From: rachelle toti <rachelletoti@gmail.com>
Sent: Tuesday, March 23, 2021 9:50 AM
To: boardclerk@slocleanair.org
Cc: Gary Willey; Karl Tupper
Subject: [EXT]Comments for the Hearing Board
Attachments: 90MoreAcres_Option1_20201022.pdf; 90MoreAcres_Option2_20201022.pdf; 90MoreAcres_Option3_20201027.pdf; 90MoreAcres_Option4_20201027.pdf

As you watch the presentations during the March 24 Update there are at least four issues that are concerning.

Option 4

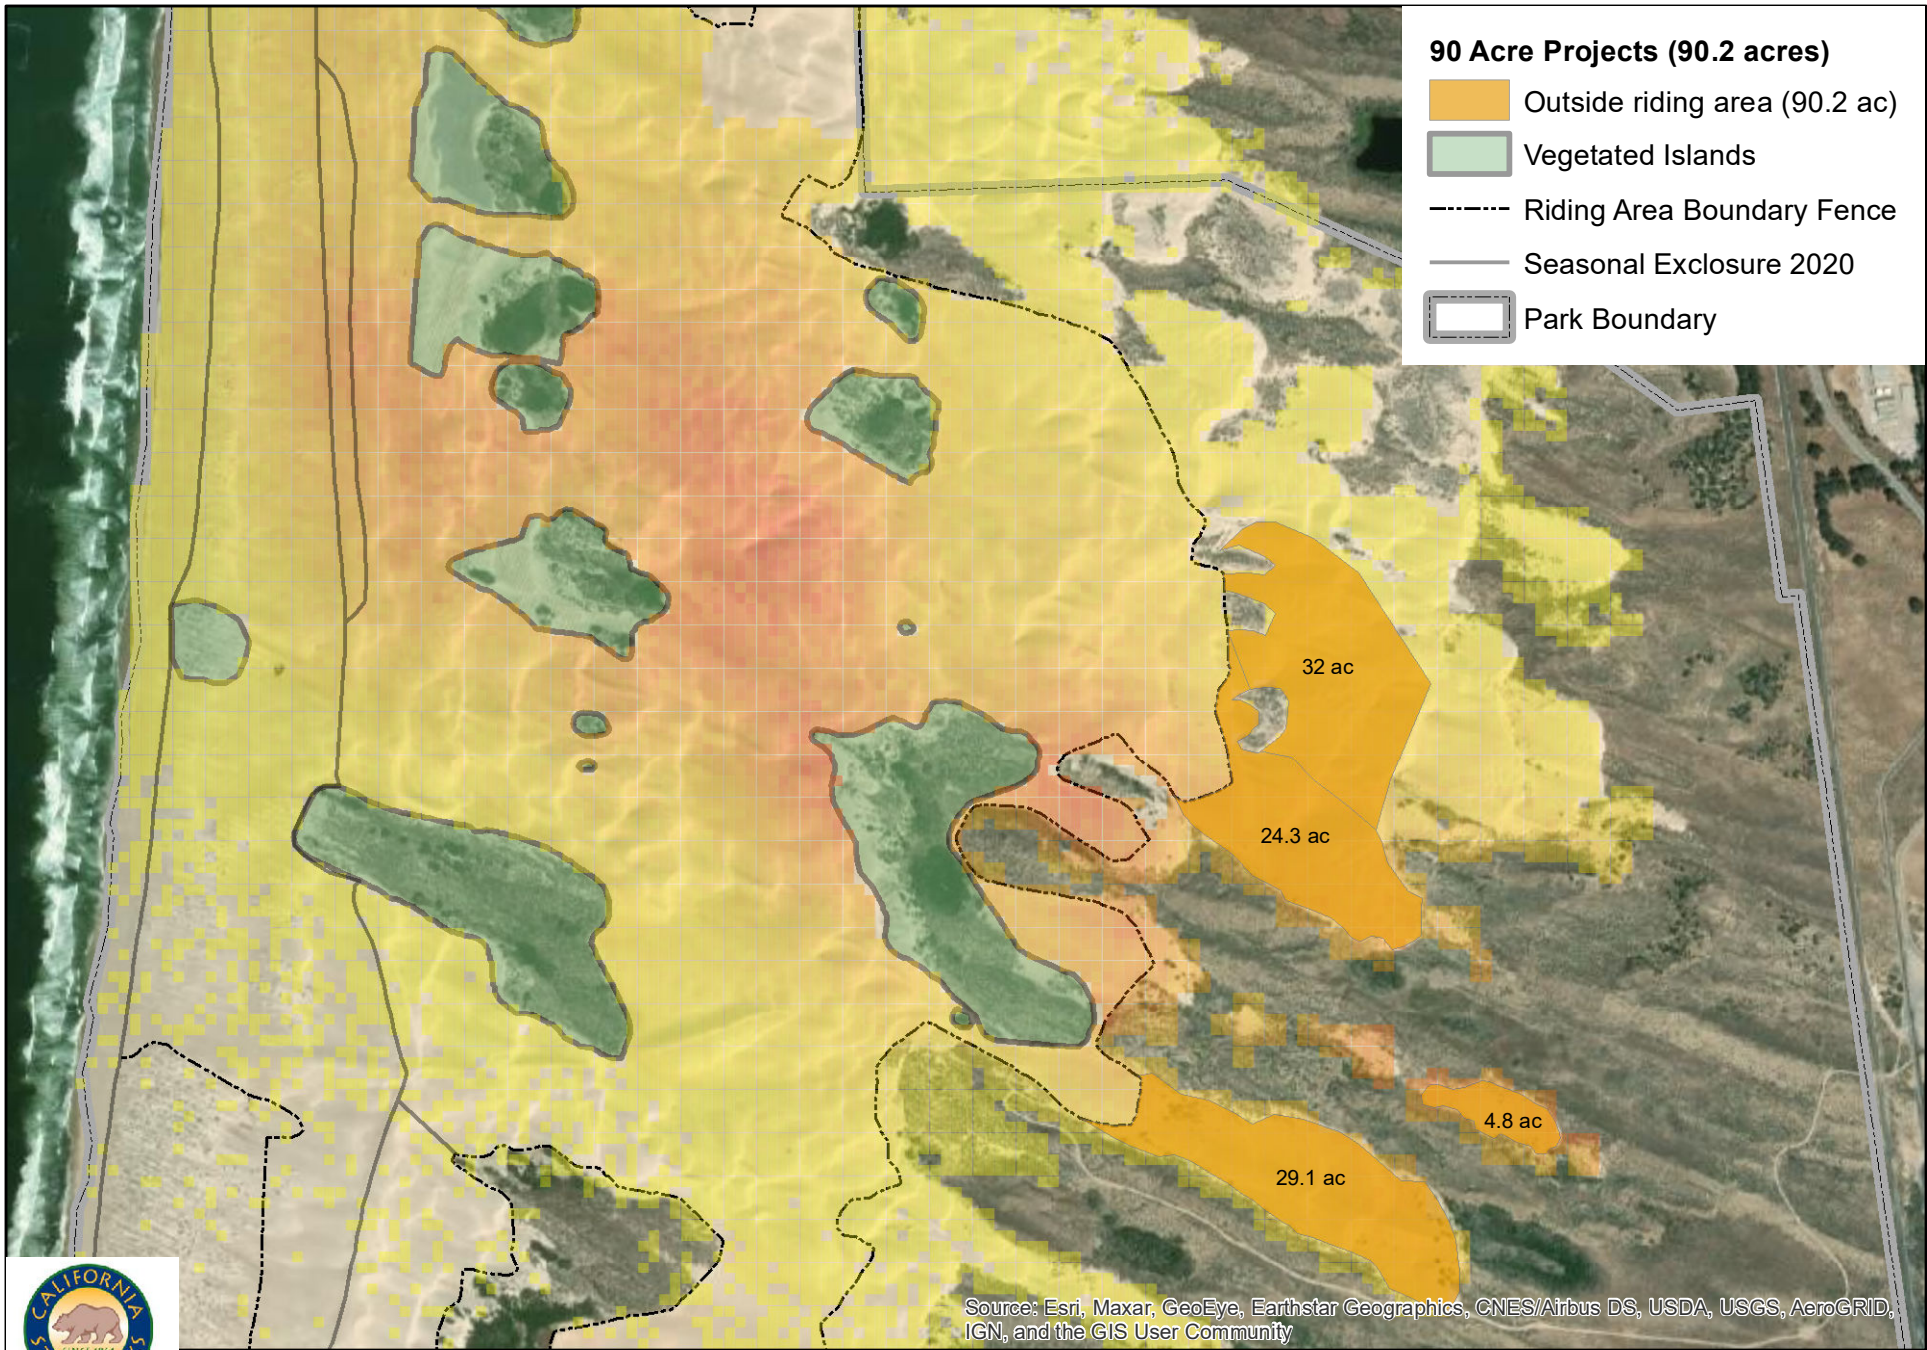
1. Timing - Why is the 2020/ 2021 dust mitigation being installed so late when it was approved in November?
2. Location - Why is 25% of this mitigation outside of the riding area?
3. Transparency -Why weren't the four options for mitigation presented to the APCO and the public in August 2020. I had to obtain them with a Public Records Act request, and then it took 2 months. See attached options.
4. Accuracy - Are the acres of mitigation being accurately counted and not double-counted. For example, 40 acres is fenced one year, awaiting native plants to be planted at a later date. When that later planting occurs in another year, or maybe 2 years, (20 acres one year and 20 acres in another year), are they being counted again as mitigation once planted.
